MITCHELL CONCRETE

BIRTKER CONSTRUCTION
MEADOWVIEW

PLEASE GET APPROVAL ON THESE COLD JOINT CHANGES.

RFI # 43
2 OF 3

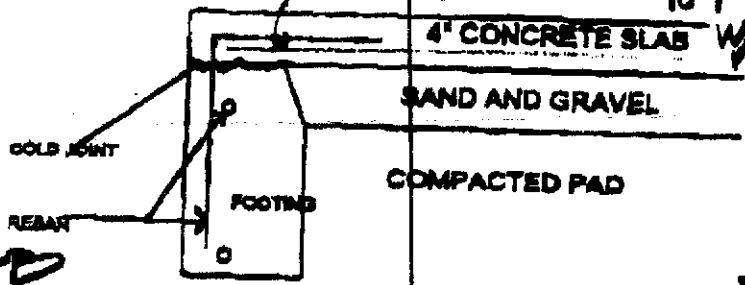
1. 2 POUR SYSTEM.

WE WOULD LIKE TO MOVE THE COLD JOINT UP TO THE BOTTOM OF THE SLAB.

I looked at this footing 5-15-00 RY

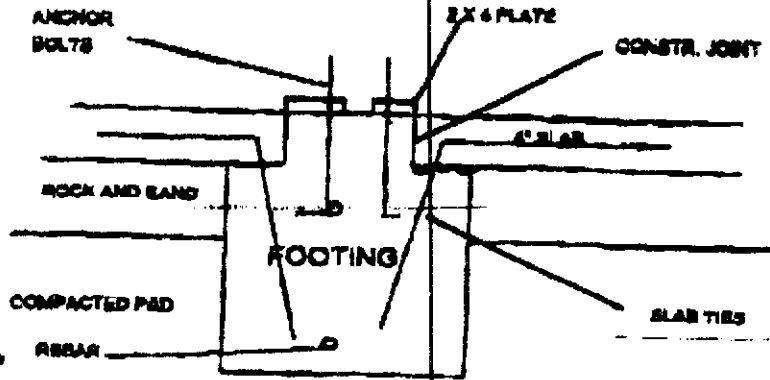
WE WOULD LIKE TO POUR A STEM WALL @ THE PARTY WALL CONDITIONS.

SLAB TIES #4 @ 18" 16" 18" DOWN
